## Customer Product/Process Change Notification

PCN # 119614  
Issued Date: 26-Jun-24  
Issued By: Jason Yost  
Author: Jason Yost

606-1415-110F  
606-1415-120F  
606-1415-130F  
606-2415-110F  
606-2415-120F  
606-2415-130F

### NEW (CLEAR LENS)

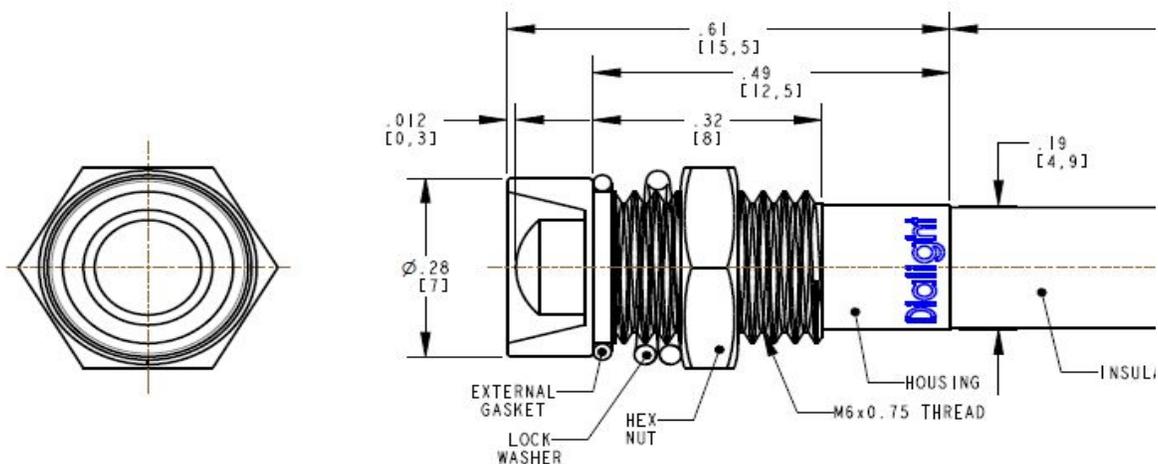
606-1415-110F- Operating voltage change from 2VDC to 3VDC, Lens change from diffused to clear  
606-1415-120F- Lens change from diffused to clear  
606-1415-130F- Lens change from diffused to clear  
606-2415-110F- Operating voltage change from 2VDC to 3VDC, Lens change from diffused to clear  
606-2415-120F- Lens change from diffused to clear  
606-2415-130F- Lens change from diffused to clear

Described above in description of change. All Product had Form (lens) and some had function changes occur in 2020. To help indistinguish the original part that was 2 volts you will find a gold label on unit indicating the part number / the new part will have the part number printed directly on the housing.

### OLD (DIFFUSED LE

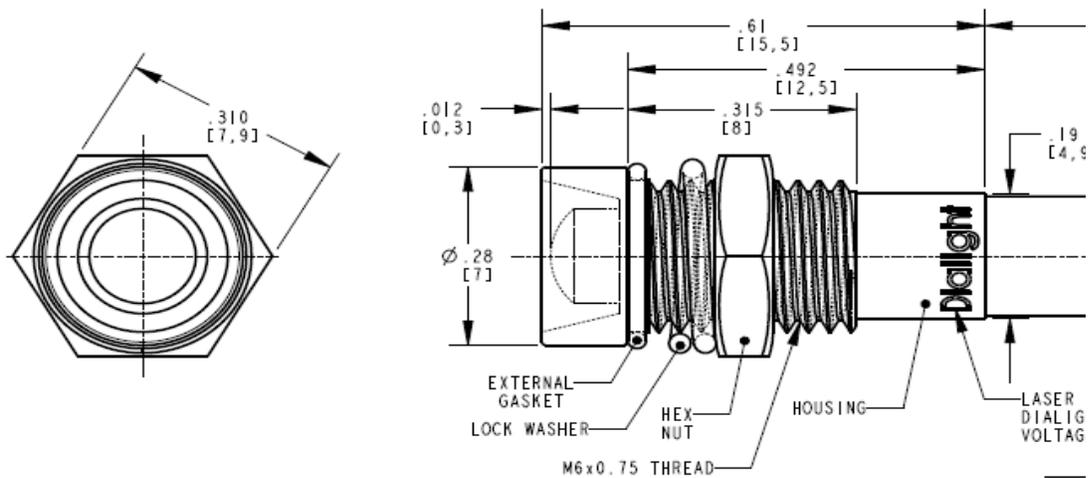
Since change was made in 2020, no more stock should be left of the old part. If there is, old product will have a diffused lens and should be removed from inventory. If previous part is desired, new part numbers have been created with different End suffix in nomenclature to avoid mixing inventories.
